DISCUSSION of:

Ground Improvement Using Preloading with Prefabricated Vertical Drains

Full Reference: Dhar, A.S., Siddique, A., Ameen, S.F., (2011). Ground Improvement using Pre-loading with Prefabricated Vertical Drains. International Journal of Geoengineering Case Histories, <http://casehistories.geoengineer.org>, Vol.2, Issue 2, p.86-104. doi: 10.4417/IJGCH-02-02-01.

Bengt H. Fellenius, Dr. Tech., P.Eng., Canada; email: bengt@fellenius.net

Figure 1. Settlement measured at the benchmarks shifted 10 days.

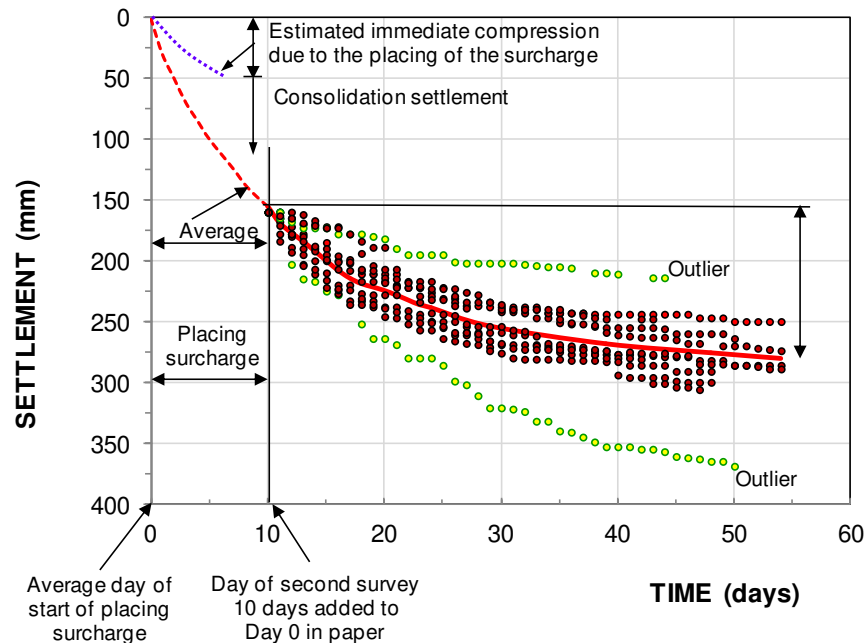
The authors report, that the first survey of the benchmarks was taken before the 3.0-m surcharge was placed across the test area. The first day of settlement measurements for the twelve benchmarks was the date of the second benchmark survey, which was carried out only when all of the surcharge had been placed to the full height over the test area. The time between the first and second surveys—and the placing of the surcharge—ranged from a few days to twenty days. Because the times between the placing of the surcharge and the second survey differed for the benchmarks, the amount of settlement that had occurred at the time of the second survey also differed between the benchmarks. This explains some of the significant scatter displayed in the authors' Figure 13. I have re-plotted the measured settlements in Figure 1 to a common starting point at the average start settlement of 160mm and added 10 days to the authors' measurement days to indicate the average duration of placing the surcharge, which took place before the second survey. During this time, immediate compression and some consolidation will have occurred. As indicated, I estimate the immediate compression to be about 50 mm. I have also added an average curve and extrapolated it back to the origin (the average excludes the two outlier records). All benchmarks appear to show that most of the consolidation had developed at the time the last survey was made.

Figure 2. Settlement measured at the benchmarks normalized to the average end values.

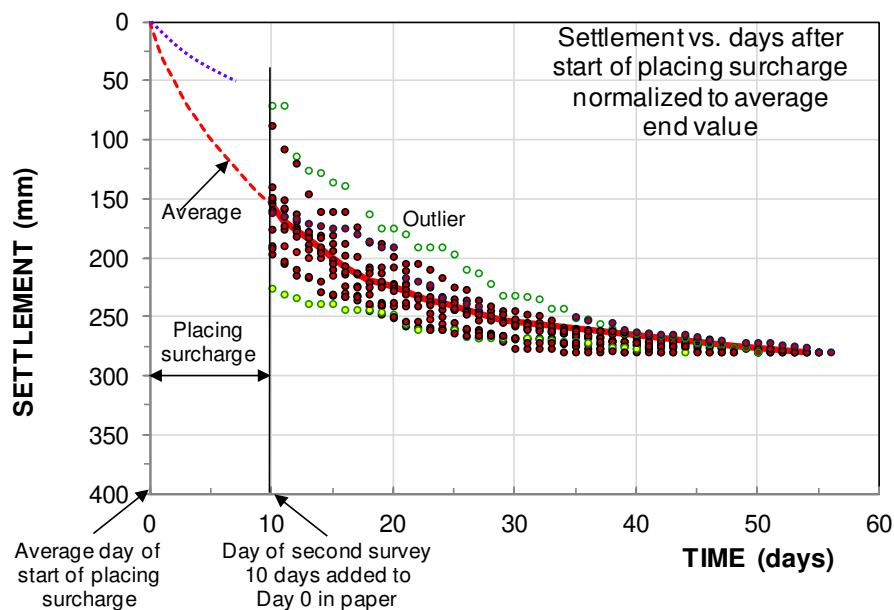
Figure 2 shows the measured final settlements are normalized to the average final settlement (280 mm). There is still much scatter between the curves, but now the approximate start date for each curve can be obtained by sliding the curves left or right until the best agreement to the average curve is obtained as shown in Figure 3. The removal of much of the scatter—the agreement between the time-settlement curves—is of course to some extent fictitious as the benchmark measurements cannot be expected to be all that similar; a natural variation must have taken place, not least with regard to the thickness of the soft clay layer. However, I believe that the figure suggests a reasonably realistic day for the start of placing the surcharge.

Figure 3. Settlement measured at the benchmarks adjusted to obtain the approximate start day.

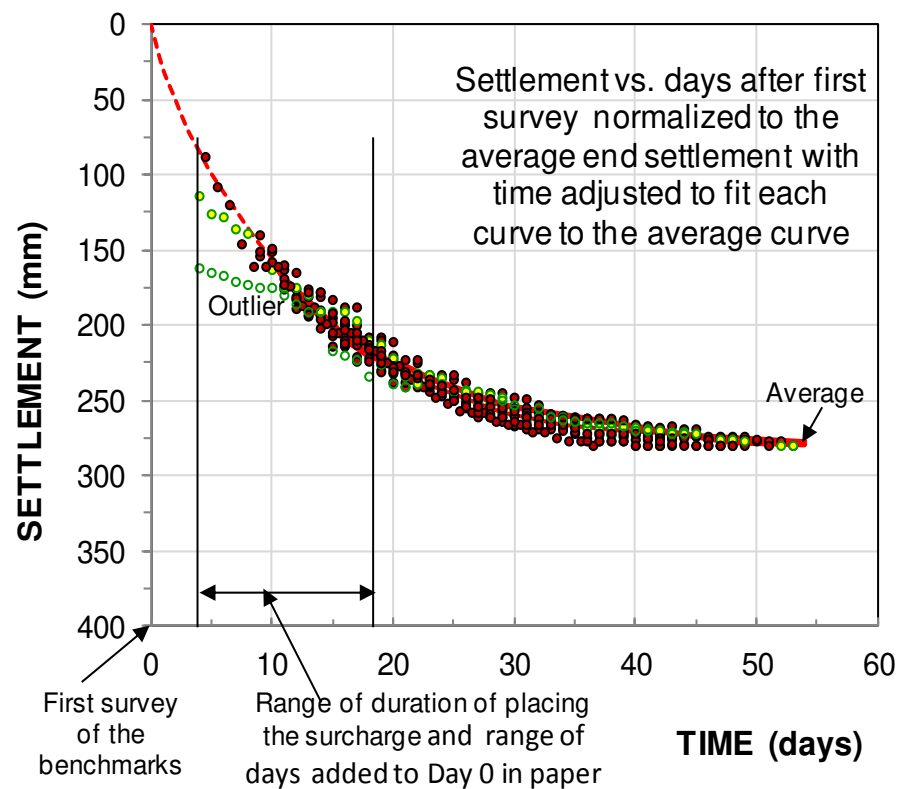
The average curve shown in Figure 3 can now serve as reference to a back-calculation of the time-settlement development for the wick-drain project to determine compressibility and coefficient of consolidation of the soil layers. The back-calculation consists of applying the theory of pore pressure dissipation in fine-grained soils (consolidation) due to radial flow (Barron 1948, Kjellman 1948, and Hansbo 1960; 1979) is based on radial flow toward a circular drain in the center of a cylinder of homogeneous soil with an impervious outer boundary surface). The theory is summarized in the Kjellman-Barron formula, Equation 1. The Kjellman-Barron formula is based on the assumption of horizontal (radial) flow only and a homogeneous soil.

Figure 4. Average measured and calculated settlements.

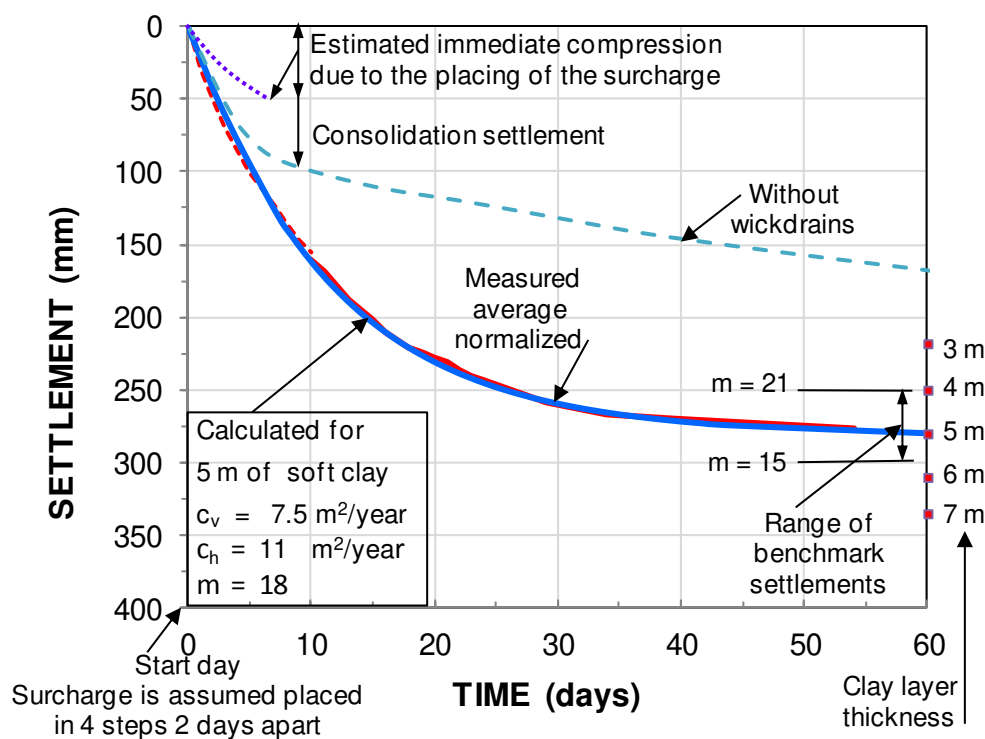
The results of the back calculation are shown in Figure 4 together with the average curve of the measurements. In order to show the sensitivity of the clay layer thickness and modulus number, the figure also shows the final settlement for soil layer thickness ranging from 3 through 7m and the final settlement resulting from modulus numbers of 15 and 21. The figure also shows the settlement during the first 60 days that would have occurred had there been no wick drains (for this input, I used the authors' 7.5m²/year c_v -coefficient).

Considering that my data reduction is quite different to that of the authors, my back-calculated c_h -coefficient (11m²/year) agrees well with the authors' laboratory-established value (14m²/year). The difference could be taken to represent the effect of a smear zone. However, considering all the uncertainties involved, I believe the agreement to be entirely fortuitous.
